**Re: Site Plan and Special Permit – Taj Estates of Franklin II  
230 East Central Street, Franklin, Massachusetts**

**Proposed Retaining Wall  
230 East Central Street  
Franklin, MA 02038**

Date: May 19,2022 Job No.: 18.04830 Task 81  
To: Amy Love, Town Planner  
Cc:  
From: Gary D. James, P.E.  
Subject: **230 East Central Street**

**DATE:** May 18, 2022  
**TO:** Franklin Planning Board  
**FROM:** Department of Planning and Community Development  
**RE:** 230 East Central St – Taj Estates  
Special Permit & Site Plan

Sheet Pile Retaining Wall

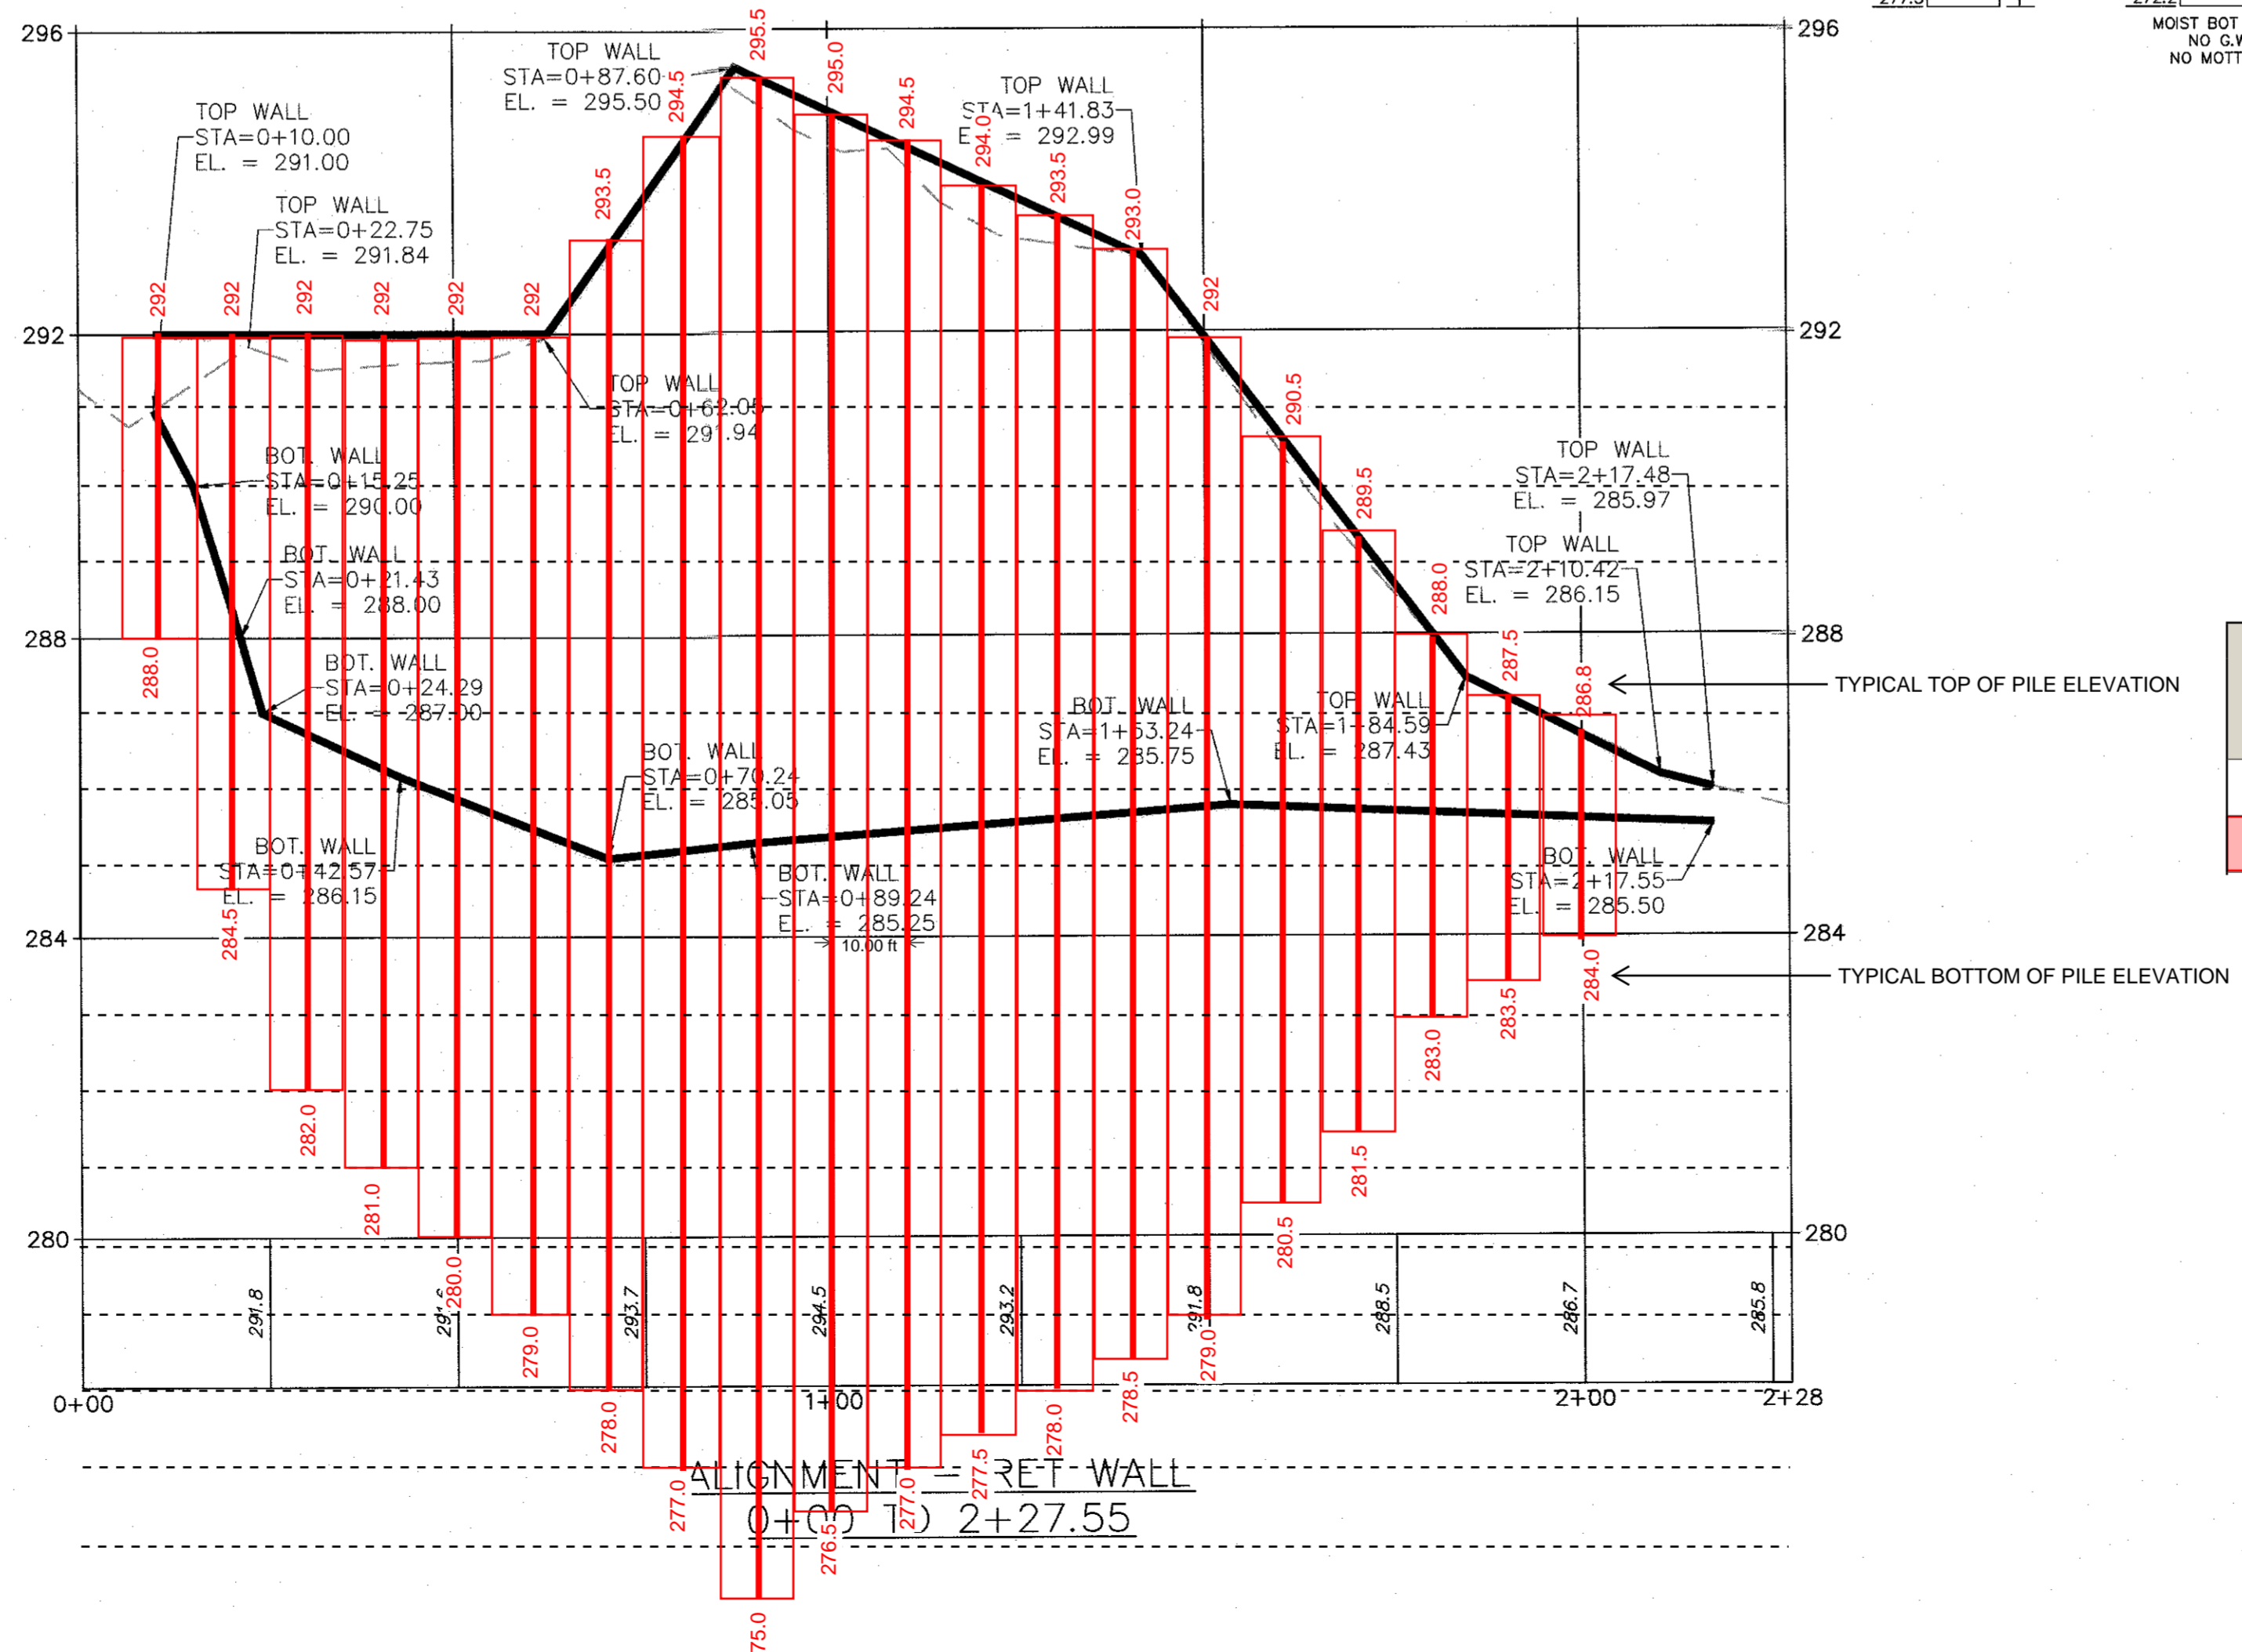
The plan has been prepared to address the issues associated with the proposed grading within the limits of the Hill Avenue Right of Way along the westerly edge of the site and construction of a retaining wall along this property line. To eliminate the issues associated with the grading and excavation associated with the construction of a retaining wall along this property line, the applicant is now proposing to drive a PZ27 Steel Sheet Pile Wall. As proposed, the wall will start 43'± back from the front face of the building and extend 207'± southward beyond the parking spaces. Based upon existing grades and the proposed building slab elevation, the height of the wall will vary from 1' -10'. The tallest sections of the wall will be opposite the proposed first floor garage and along the proposed pavement area behind the building. Based upon the design plan, we have the following comments.

1. The natural grades in the center section of the wall exceed 30%. The design engineer should be prepared to discuss and present to the Planning Board a construction means and method to access this portion of the site and install the sheet piling.

2. The dimensions reflected on Sheet 4 of 12 of the record site plan drawings prepared by G & H, should reflect the dimensions from the building and the property line to the wall accounting for the width of the proposed sheet pile section.

3. At 10' high, the wall will require a fence along the top to prevent accidental falls. BETA recommends that a detail be provided to show the proposed fencing, including height, type, and material and relationship to the property line and the sheet pile wall.

4. If the intent of the wall installation is to maintain a 9' wide access corridor around the structure than the width at the top of the wall between the wall and the property line will only be 0.8'. Installing a fence along this strip will require the use of the right of way for construction access. BETA recommends that the applicant's attorney address this issue regarding access rights beyond the property line within the right of way.

5. The test pits conducted on site were all outside of the steep grades towards the middle of the lot. The sheet pile sections near STA 1+0 will need approximately 20' of penetration into the ground. Based upon the exposed ledge on the opposite edge of the right of way, what is the design engineer's contingency if you are unable to achieve the penetration depth due to ledge.
6. BETA recommends that the existing trees around the wall be located to see if any outside or on the property line will be impacted or need removal to install the sheet piling.
